# Slieveacurry Renewable Energy Development

Stage 1 Road Safety Audit

Alan Lipscombe Traffic & Transport Consultants

April 2026

Figure 2.3 – Location Where Passing Motorists Could Access the Overrun Area (When Not in Use)

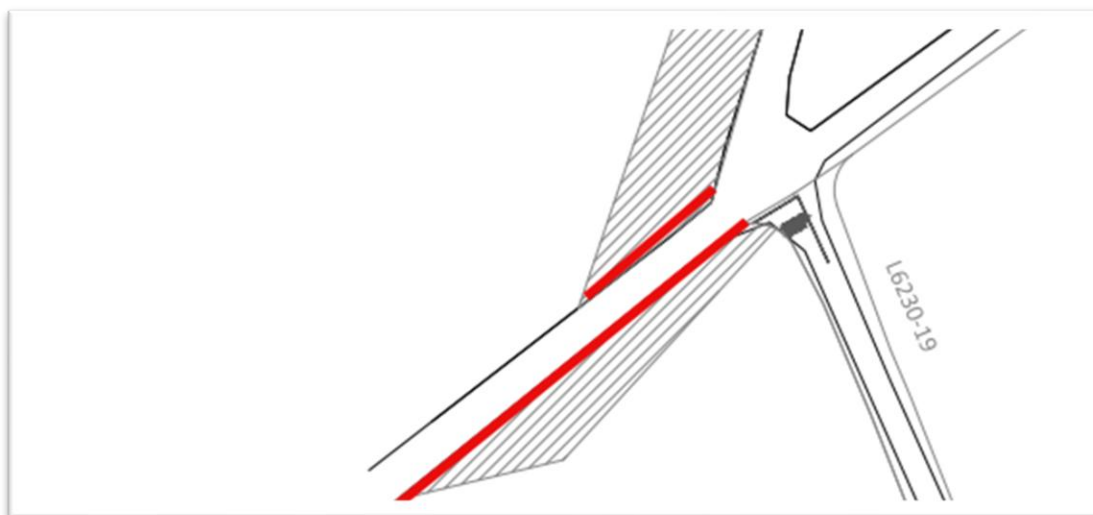
**Location:** Location 5 - L1076 / L6230 junction | Local Roads to the North & West

The temporary over-run area might create confusion for passing motorists, who could access it by mistake, leading to sudden braking, loss of control or conflicts with construction traffic.

The Designer should ensure that a suitable barrier is put in place to prevent passing motorists from accessing the abnormal load overrun area when it is not in use.

2.3	Yes	Yes	A suitable barrier will be installed at all times and opened only on the nights that the abnormal loads are delivered	Noted and accepted
2.4	Yes	Yes	It is confirmed that the visibility splays and forward visibility shown in Figures 15-19a / 15-19b will be provided at all times.	Noted and accepted

Figure 2.5 – Location Where Passing Motorists Could Access the Overrun Area (When Not in Use)

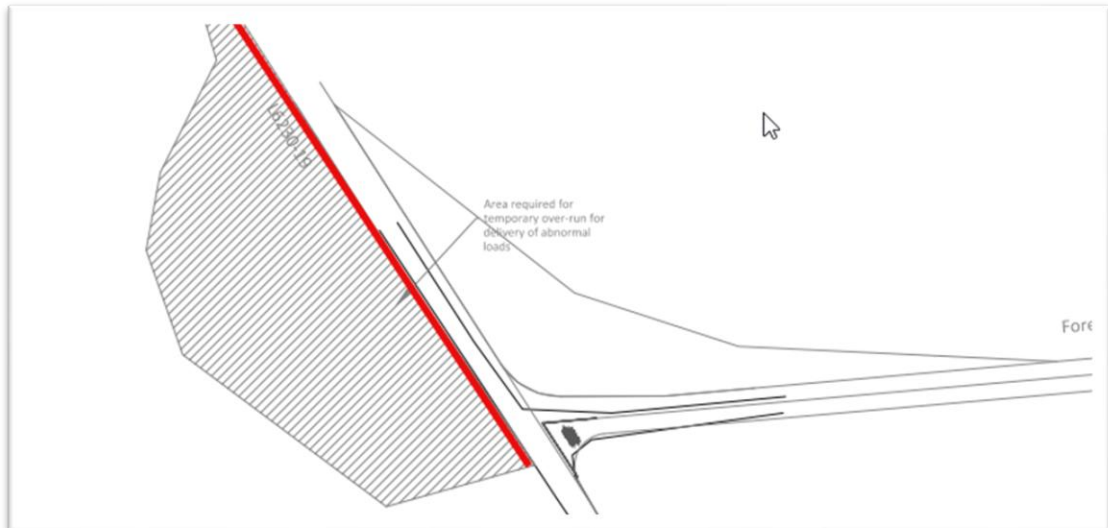
**Location:** Location 6 - L1076 / L6230 Access | Local Road to North & West

The temporary over-run area might create confusion for passing motorists, who could access it by mistake, leading to sudden braking, loss of control or conflicts with construction traffic.

The Designer should ensure that a suitable barrier is put in place to prevent passing motorists from accessing the abnormal load overrun area when it is not in use.

2.5	Yes	Yes	A suitable barrier will be installed at all times and opened only on the nights that the abnormal loads are delivered	Noted and accepted
